RE: **Palen Solar Power Project, Docket No. 09-AFC-7**
Responses to January 14, 2010 CEC Workshop Queries
Technical Areas:
Soil & Water Resources (supplemental data for DR-S&W-242)

Palen Solar Power Project

Soil and Water Data Responses to January 14, 2010 CEC Workshop Queries

DR#242 Supplemental---Soil and Water:

30% Conceptual Engineering Plans
NOT FOR CONSTRUCTION
DATED: January 28, 2010

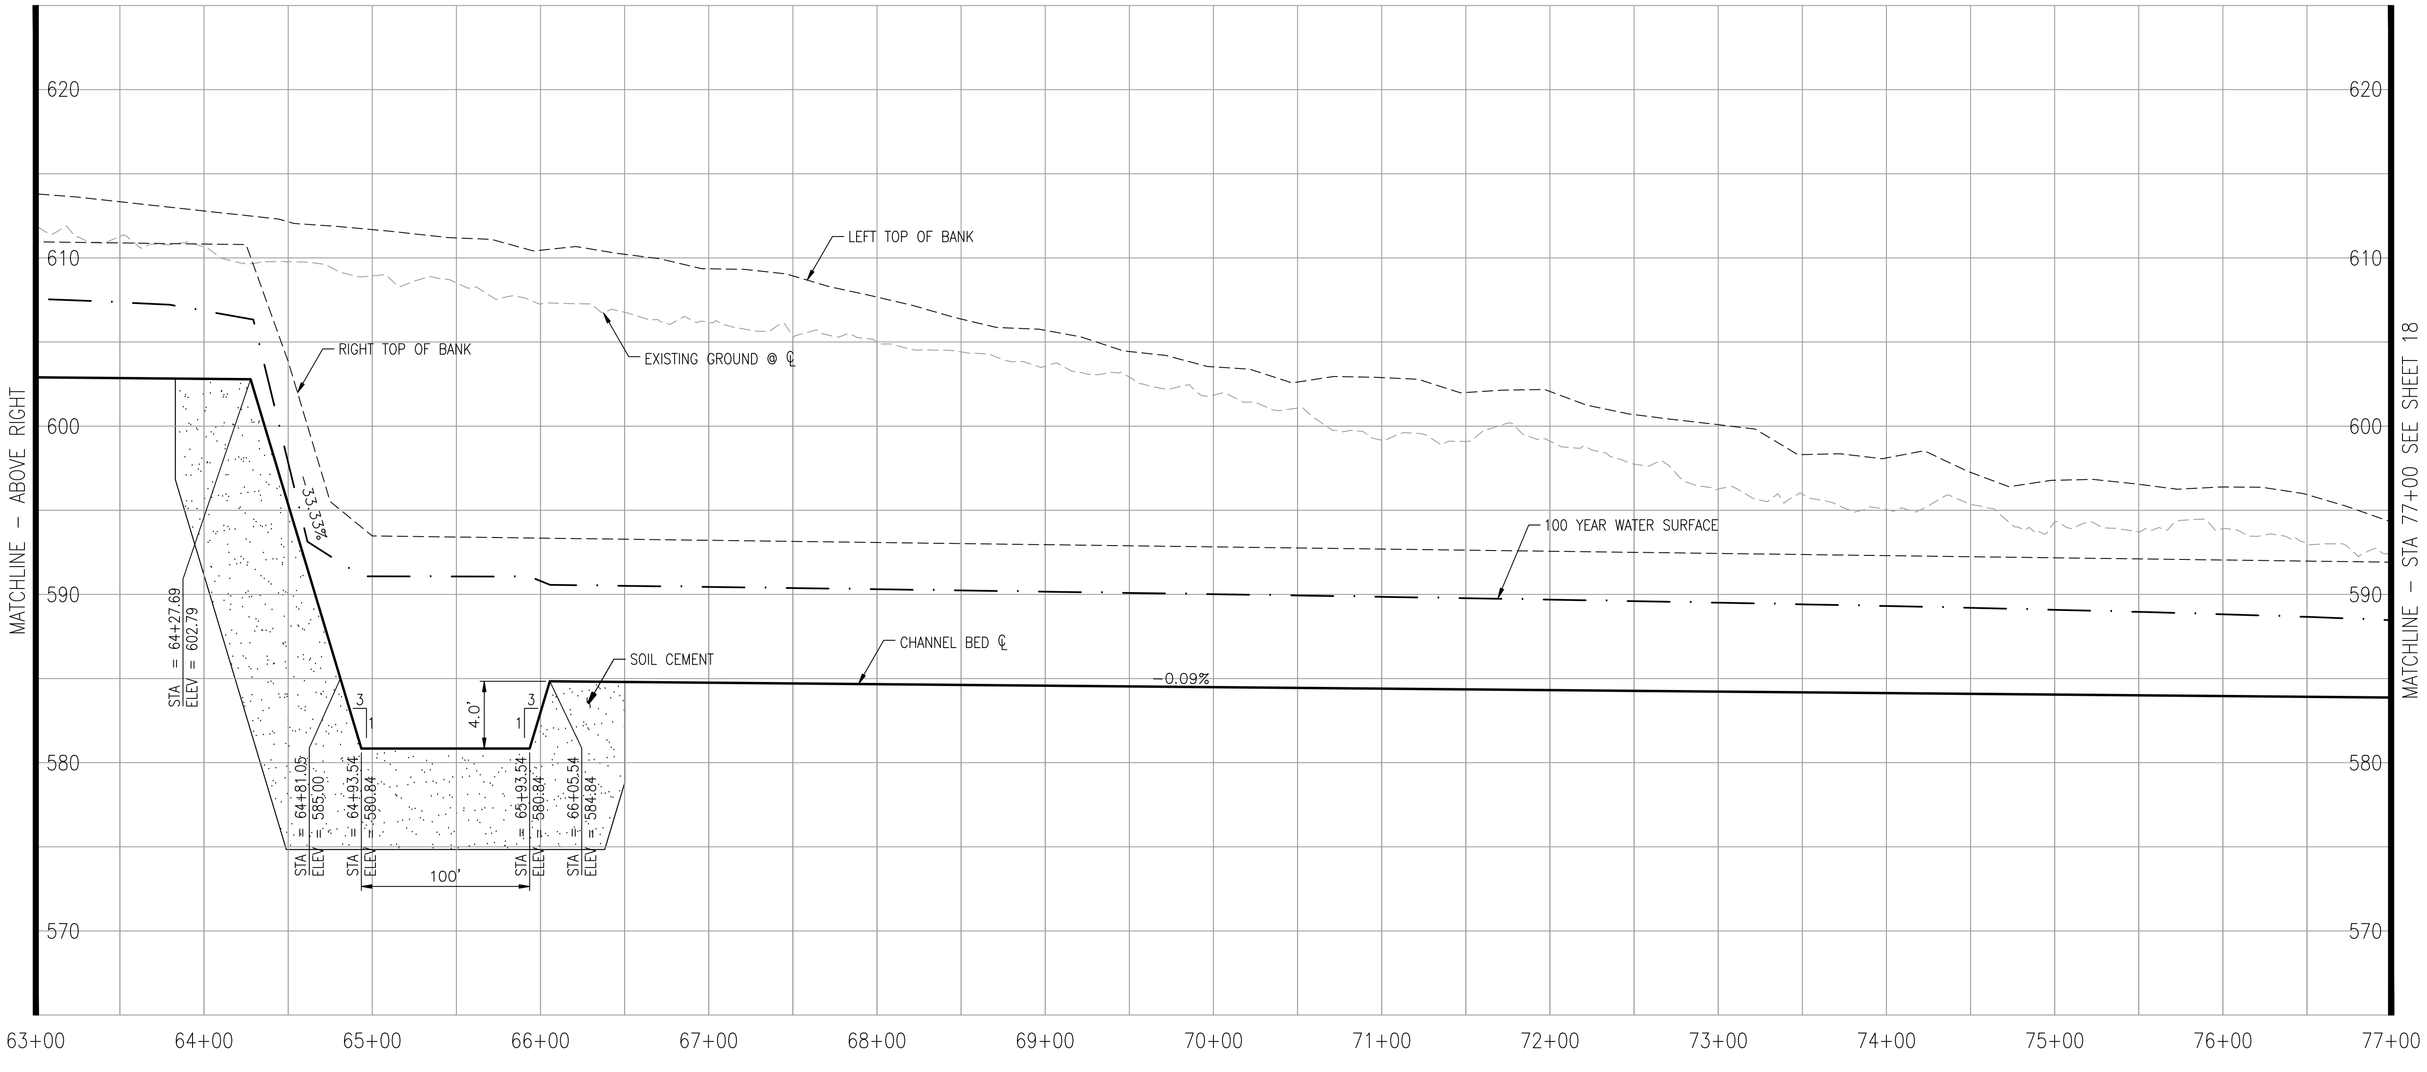
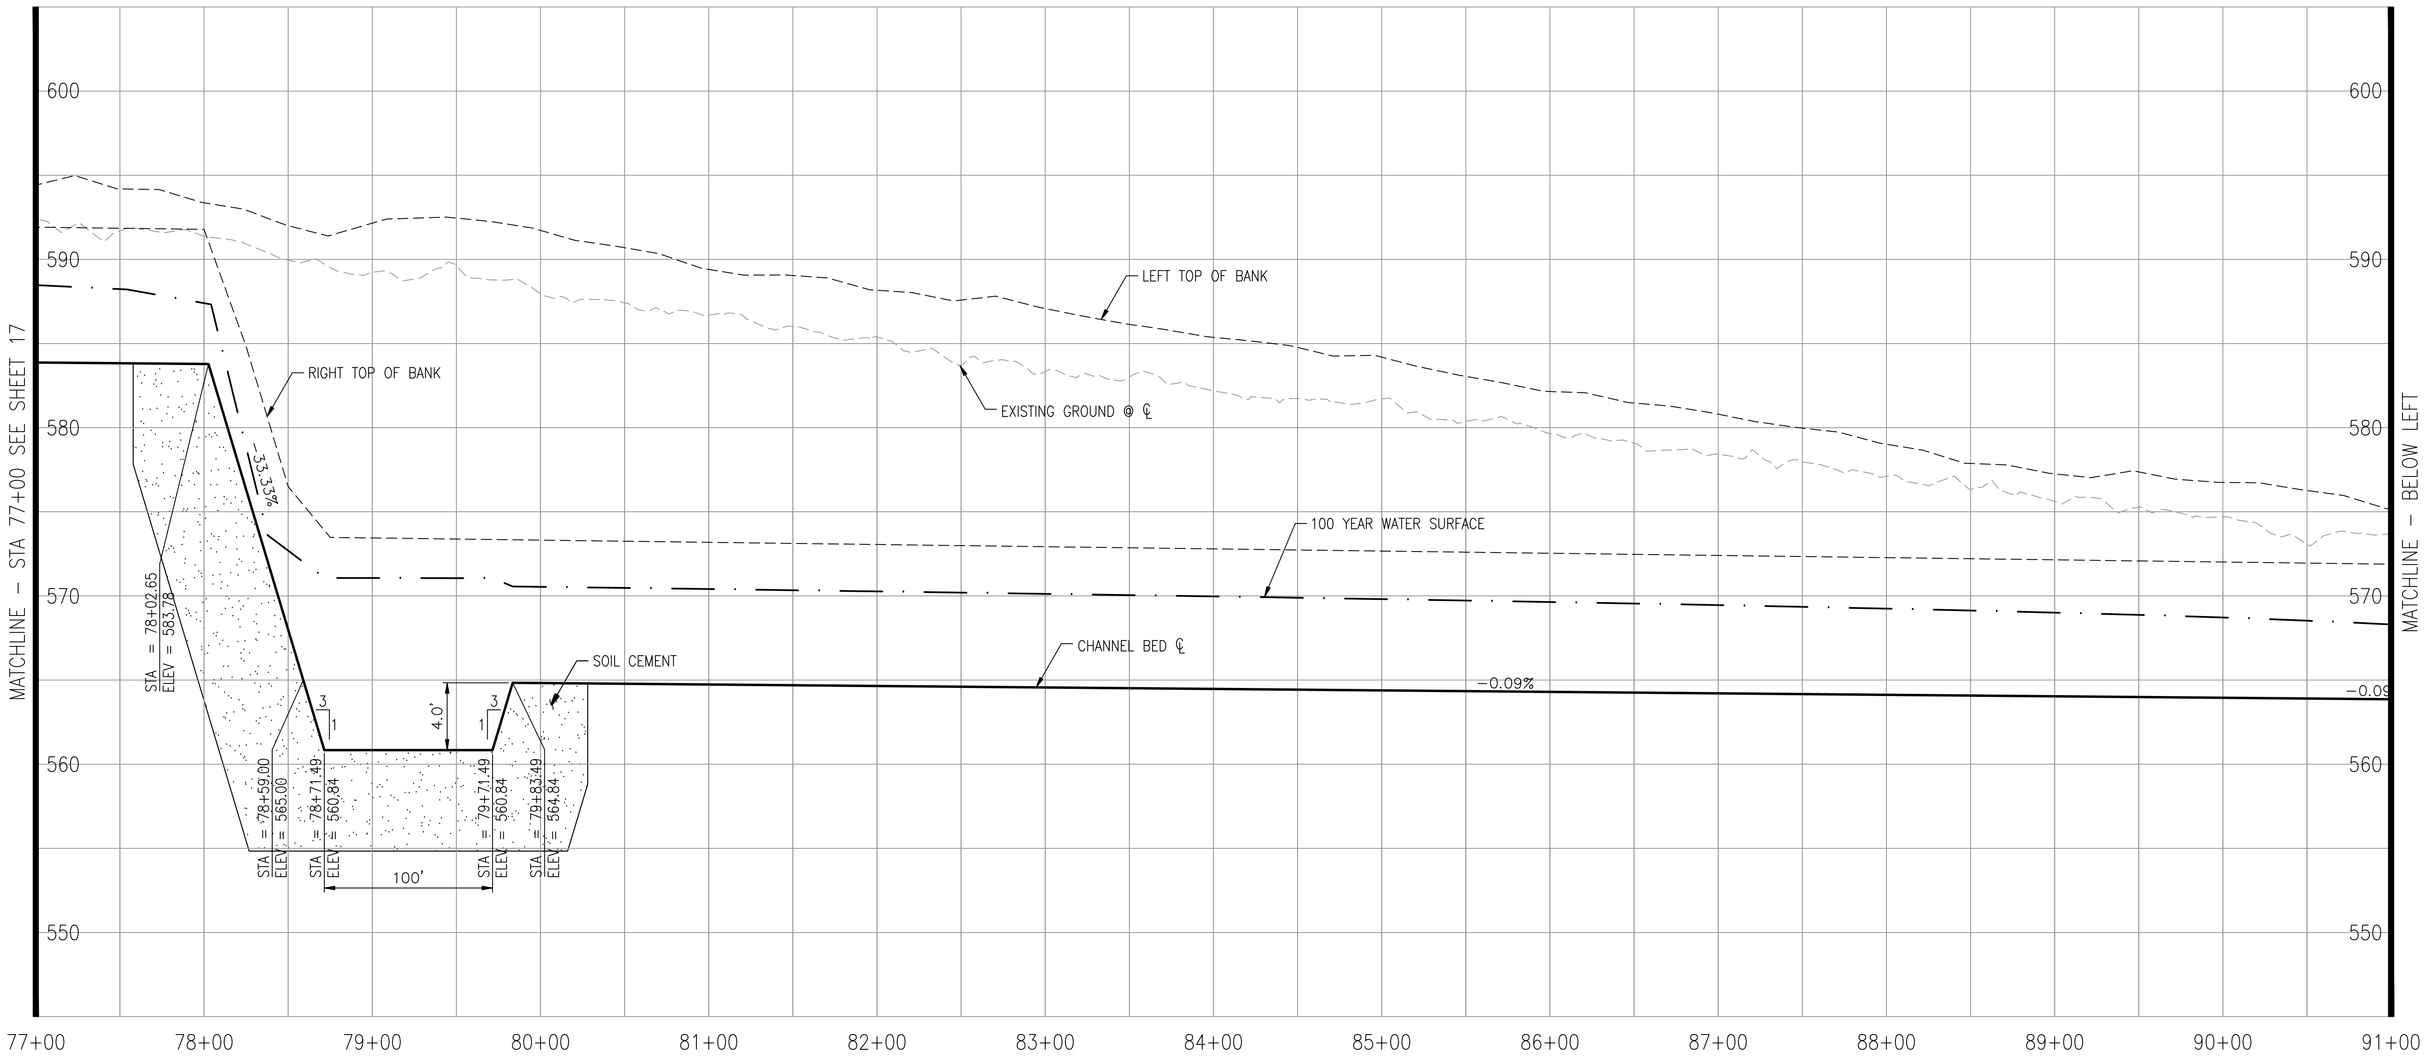
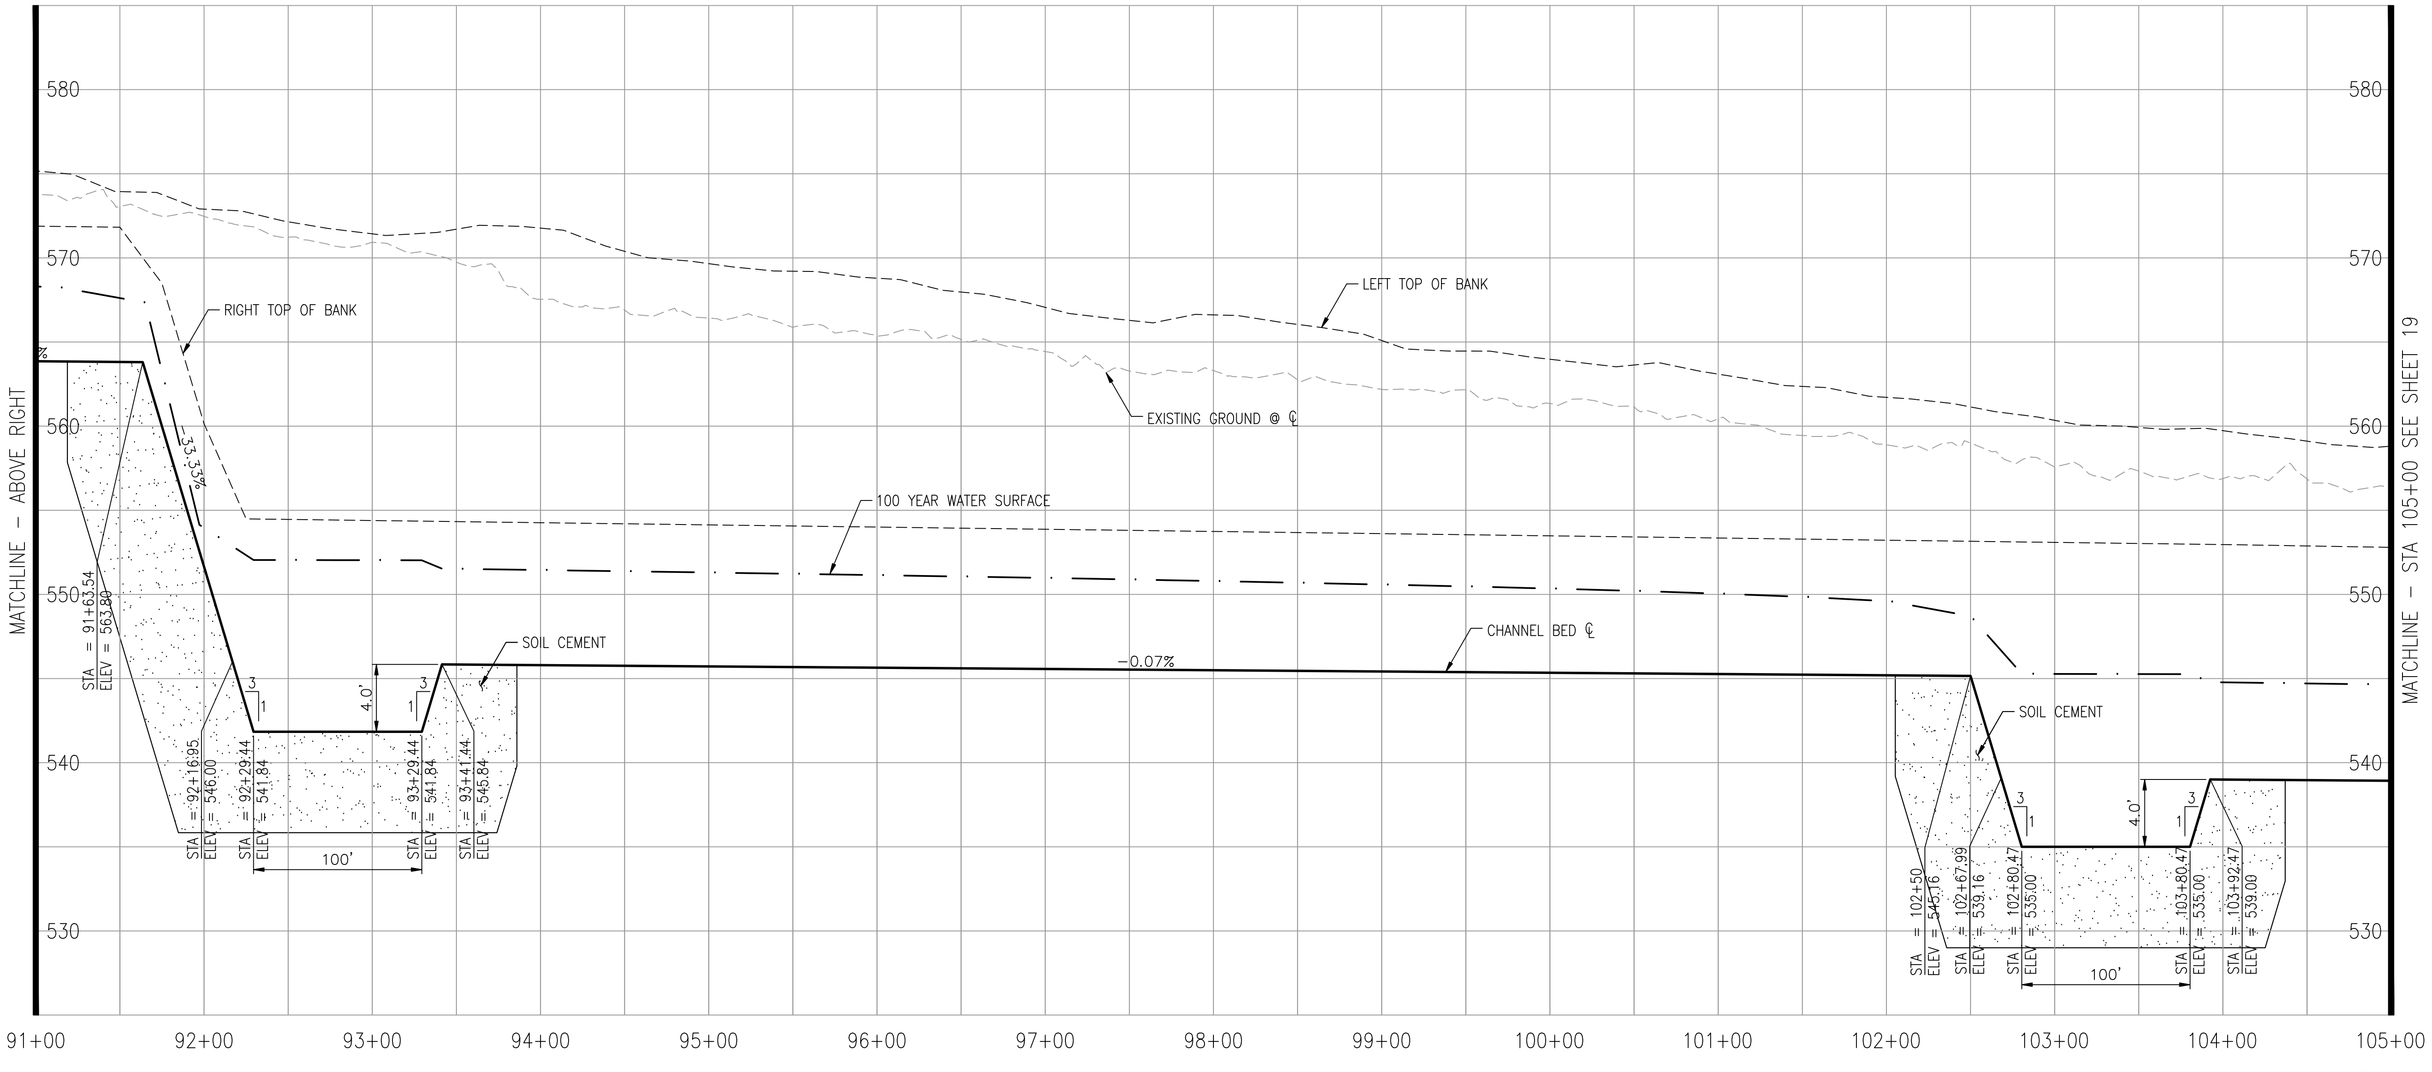
Add 100-yr. water surface elevations on profiles for main channels (both collectors and conveyance).

The 100-year water surface profile has been added to the plans and is provided as part of this response.
